# NEW BUILD SNAGGING SURVEY

## PROPERTY DETAILS

Example Survey  
3 bedroom house

e4

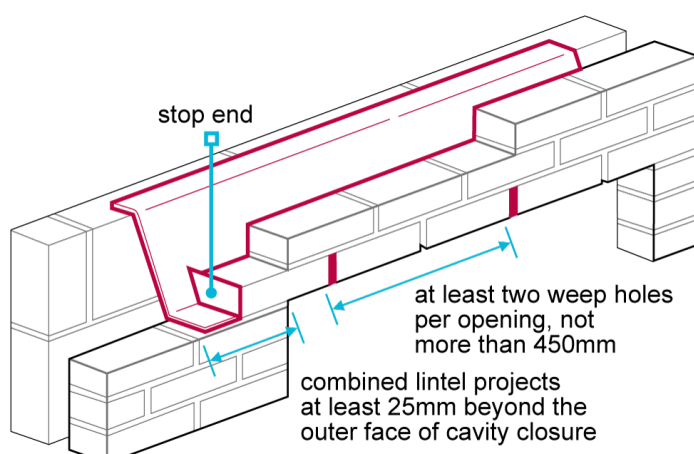
The weep vents have inconsistent spacing: they should be in 450mm apart according to NHBC 6.1.17 **Significant** ☐

L4

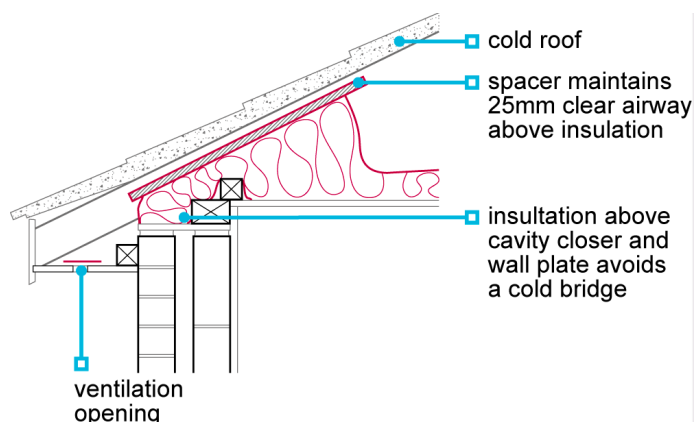
There are gaps in the insulation which need filling to prevent heat loss and condensation issues in the loft  Significant issue

sta5

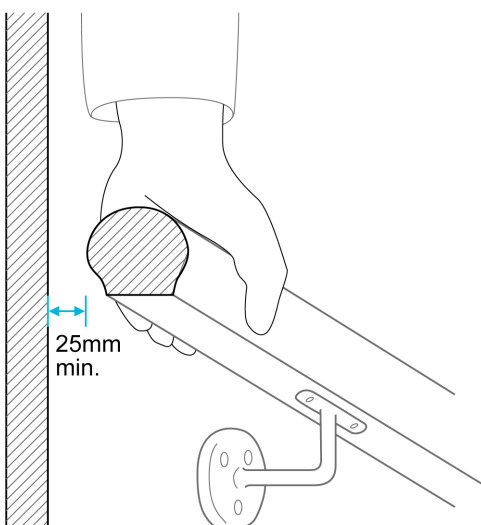
The handrail should have have a 25mm minimum clearance from any surface to ensure a safe uninterrupted grip ⚠  
Significant Issues
